# Access Compliance Report

## Public Rights-of-Way

### (Curb Ramps)

Intersection ID: 10020376	Main Street: BALLANTYNE CORPORATE PCross Street: N/A	Location:	N
ADA ID: 0F29F3AAF273	Ramp Type: Perp	Initial Pass/Fail: Fail	Overall Compliance: No
		Severity Score:	25
Codes/Mitigation Info/Possible Solution		Field Measurements/Component Compliance

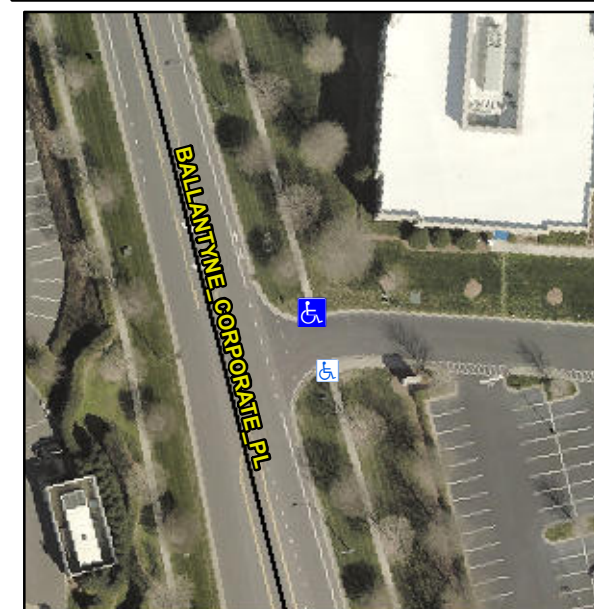
Compliance	Description	Data	Compliance	Description	Data
N/A	Ramp Length (in)	59.0	Yes	Ramp Slope (%)	6.3
Yes	Ramp Width (in)	48.0	No	Ramp XSlope (%)	9.9
N/A	Flare Type LT	N/A	N/A	Flare Type RT	N/A
N/A	Flare Slope LT (%)	N/A	N/A	Flare Slope RT (%)	N/A
N/A	Flare Traversable LT?	N/A	N/A	Flare Traversable RT?	N/A
N/A	Landing Length (in)	N/A	N/A	DWS Provided?	N/A
N/A	Landing Width (in)	N/A	N/A	DWS Contrast?	N/A
N/A	Landing Slope (%)	N/A	N/A	DWS Length (in)	N/A
N/A	Landing X Slope (%)	N/A	N/A	DWS Full Width?	N/A
N/A	Landing Curb? (Y/N)	N/A	N/A	DWS Offset (in)	N/A
N/A	Shared Landing?	N/A			
N/A	Gutter Ponding?	N/A	N/A	Gutter Slope (%)	N/A
N/A	Gutter Lip Ht (in)	N/A	N/A	Gutter X Slope (%)	N/A
N/A	Painted X Walk1?	No	N/A	Painted X Walk2?	N/A
	X Walk 1 Direction	To S		X Walk 2 Direction	N/A
N/A	X Walk 1 Width (in)	N/A	N/A	X Walk 2 Width (in)	N/A
	X Walk 1 Slope (%)	0.3		X Walk 2 Slope (%)	N/A
	X Walk 1 X Slope (%)	3.4		X Walk 2 X Slope (%)	N/A

**Remove & Replace Entire Ramp.**

**R304.5.3**
